**METROPOLITAN GOVERNMENT OF NASHVILLE AND DAVIDSON COUNTY**

**STAFF RECOMMENDATION**  
**1700 Primrose Avenue**  
**July 16, 2014**

**Application:** Partial demolition; New construction-addition  
**District:** Belmont-Hillsboro Neighborhood Conservation Zoning Overlay  
**Council District:** 18  
**Map and Parcel Number:** 11704013500  
**Applicant:** Van Pond, Architect  
**Project Lead:** Sean Alexander, sean.alexander@nashville.gov

**Proposed Site Plan**  
 Scale: 1/16"=1'-0"

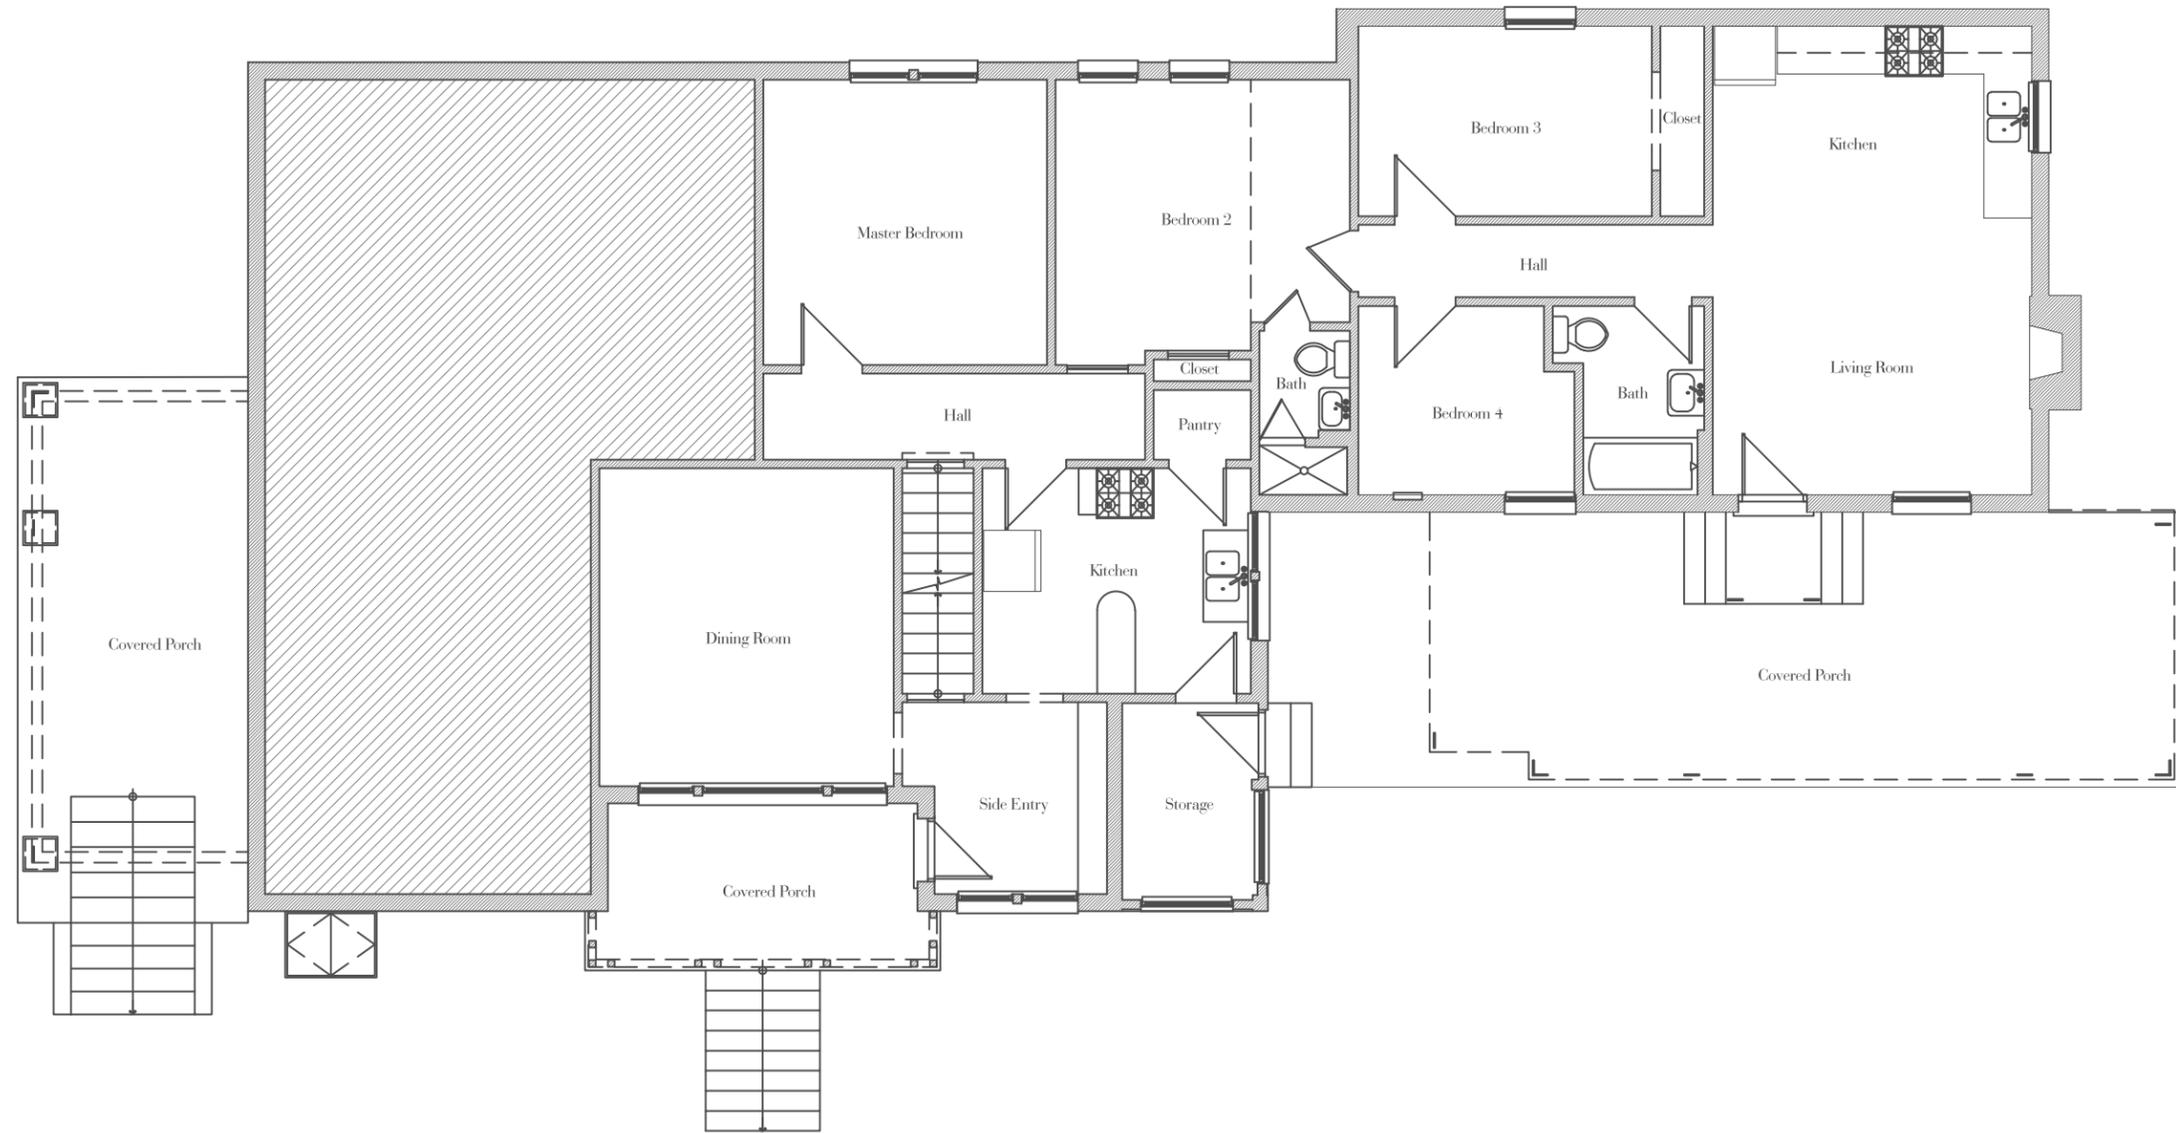
The addition will sit five feet (5') from the left side of the property, twenty-two feet (22') from the right, and twenty feet (20') from the rear. The street slopes up steeply to the west and there is a roughly six foot (6') tall retaining wall on the left side of the property that separates this property from the adjacent property. Because of this wall, and because the property widens to the right along Oakland Avenue, the perceived width of the addition will be reduced and will not negatively impact the rhythm of spacing along the street. The addition will not affect the front setback of the house.

The project meets the bulk zoning setback requirements and meets section II.B.1.c. of the design guidelines.

**Conceptual First Floor Plan**  
 Scale: 1/8"=1'-0"

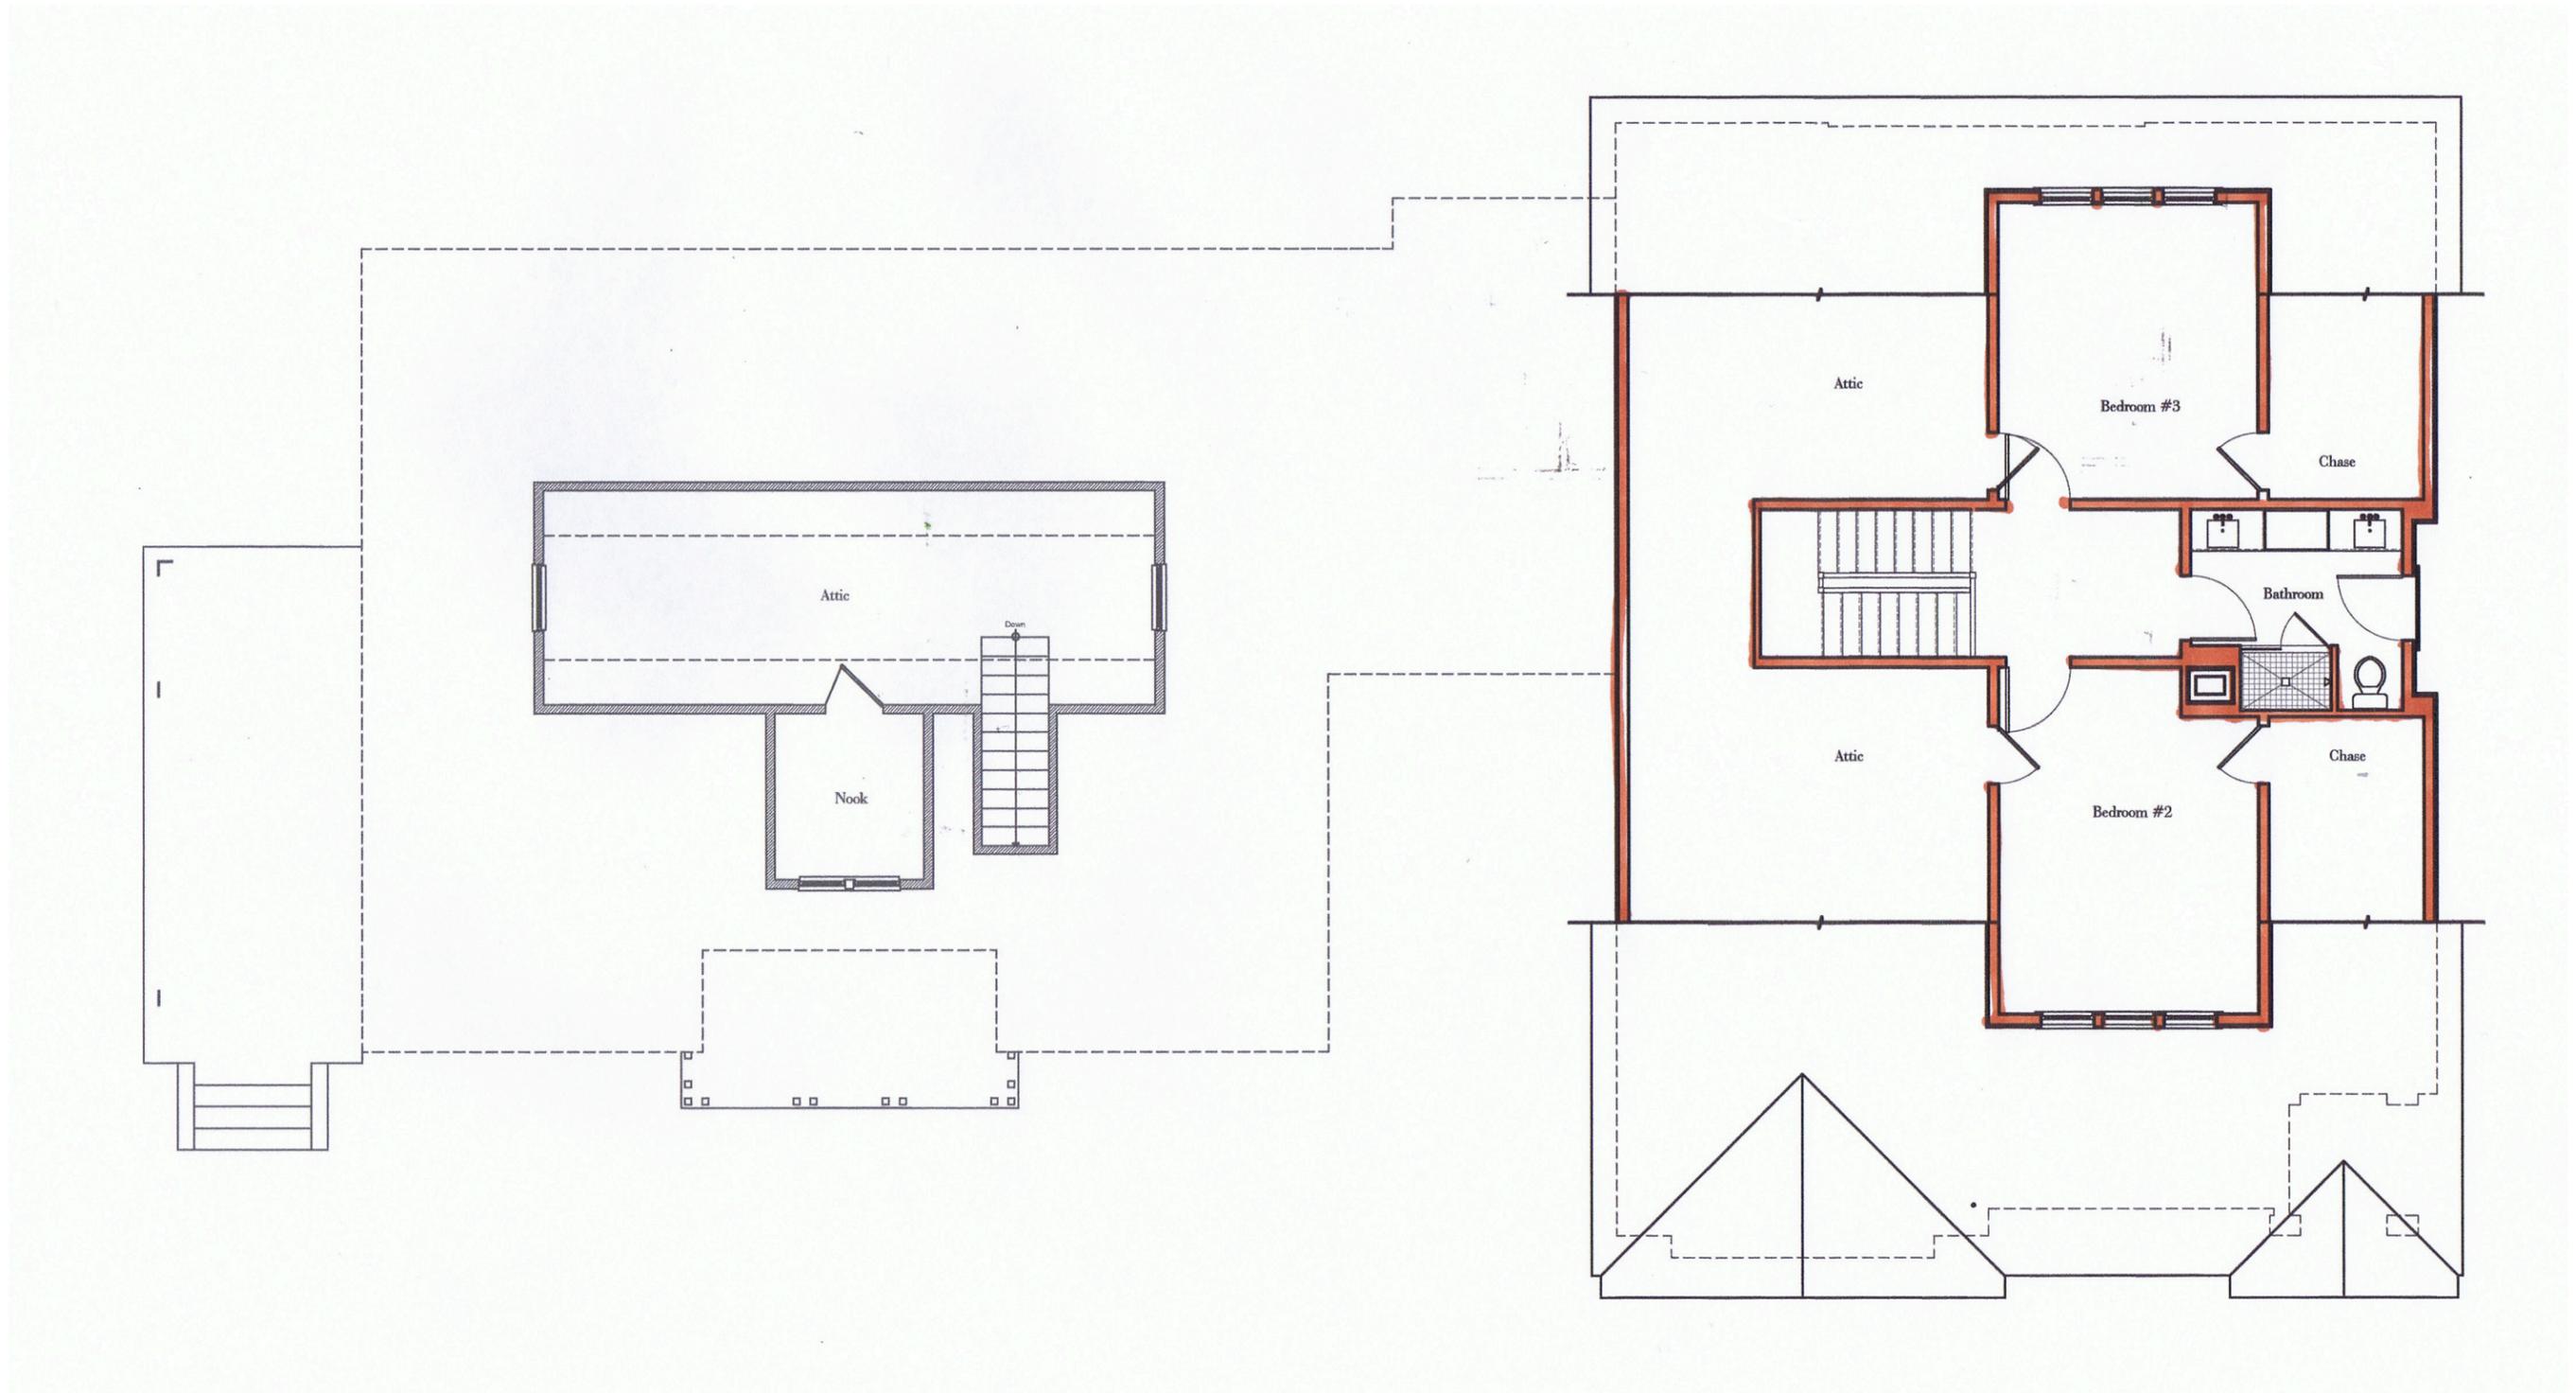
The new addition will be at the rear of the historic house in the same general location as the existing addition, although it will be wider on both sides. The left wall of the existing

addition steps two feet (2') out from the side of the historic house, and the new addition will retain a portion of this wall and then step out an additional three feet (3'). On the right side of the house, the existing addition steps in seventeen feet (17') from the side of the historic house. This inset will also be retained, after which the new construction will extend back thirteen feet (13') and then step out twenty-six feet (26') or nine feet (9') beyond the outside edge of the original building. This inset creates an uncovered courtyard between the original house and the rest of the addition on the Oakland Avenue façade, helping to break up the massing of the structure.

Although it is typically not appropriate for additions to be wider than an historic house, staff finds that the proposed addition is appropriate because there is an existing addition that steps out on the left side, and because the courtyard on the right side will sufficiently distinguish the new construction from the old. Additionally, staff finds that the addition being wider than the house is appropriate because the lot is fifty-six feet (56') wide at the front and widens to eighty-six feet (86') at the rear.

**Conceptual West Elevation**

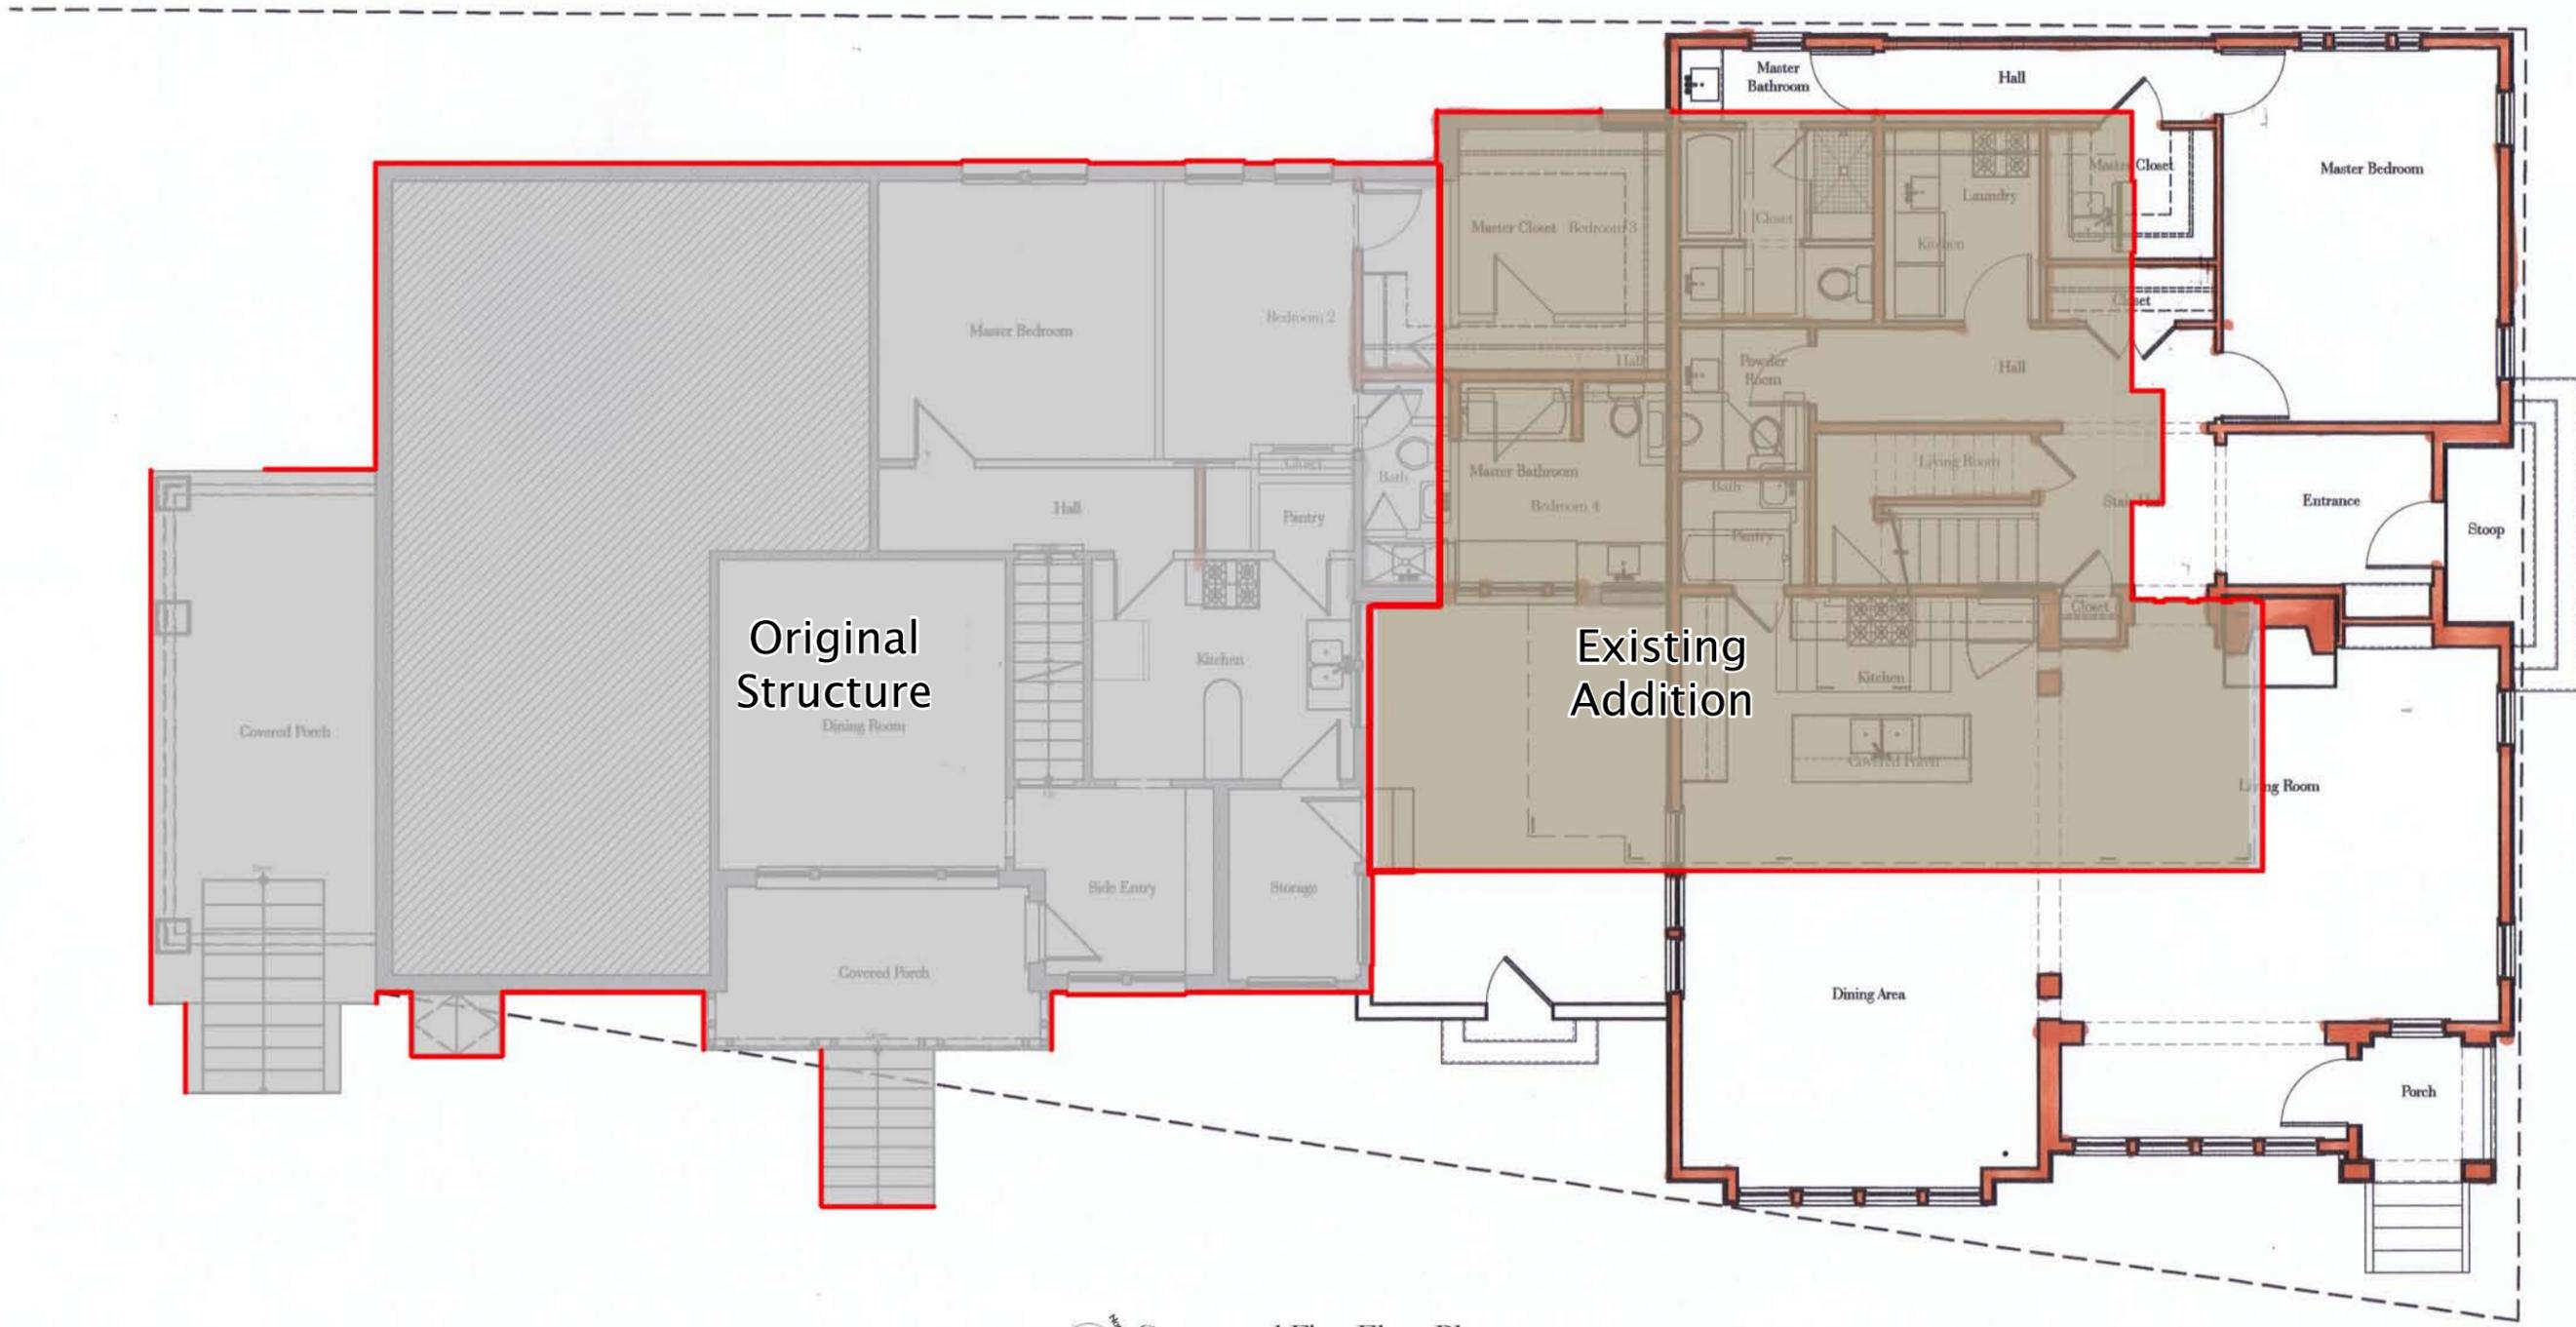
The addition will have a clipped-gable roof with a ridge aligned with, and matching the height of, the existing clipped-gable roof. The eaves of the addition will be one foot (1') lower than the eaves of the historic house and the floor level, following a drop in grade, will be two-feet, six inches (2'-6") lower than that of the house.

No major changes to the historic house's materials were indicated on the drawings. The addition will primarily be clad in smooth face cement fiberboard with five inch (5") reveal. The trim will be wood. The foundation will be brick matching the primary walls of the historic house, and the roof will be fiberglass/asphalt shingles in a color to match the existing roof. A central chimney on the addition will also be brick to match the existing walls. The new stoop and rear porch will have concrete floors and stairs with wooden handrails, and a second-story Juliette balcony on the rear will also be wood. The windows and doors will be wood, and staff asks to approve the final window and door selections prior to purchase and installation. A projecting bay on the right side will be primarily windows, with cement fiberboard trim and mullions. With the staff's final approval of the windows and doors and brick color, texture and dimensions, staff finds that the materials meet guideline II.B.1.d

The roof of the addition will be a clipped gable, with smaller clipped gables on the roofs of dormers, a projecting bay, and a right side stoop. The pitches of the addition roofs will be 6:12. This is compatible with the roofs of the existing house, which is also a clipped gable with smaller clipped gables on a dormer and bays, but with a 7:12 pitch. The difference in pitch will not be easily perceived because the two primary roof sections will be separated by the courtyard in the middle of the right elevation. The new dormers will sit one foot (1') below the primary ridge, which also matches the configuration of the dormer on the historic house. The addition will have a central brick chimney with proportions similar to a chimney on the historic house.

No changes to the window and door openings on the existing house were indicated on the plans. The windows on the proposed addition are all generally twice as tall as they are wide, thereby meeting the historic proportions of openings. The windows will also have square bulkhead panels below them to further accentuate their vertical expression, with some of the panels being solid and some with glass. There are no large expanses of wall space without a window or door opening. Staff finds the project's proportion and rhythm of openings to meet Section II.B.1.g.

- The selections of windows and doors and brick color, texture and dimensions are approved by MHZC Staff; and
- The HVAC be located on the rear façade, or on a side façade beyond the midpoint of the house.
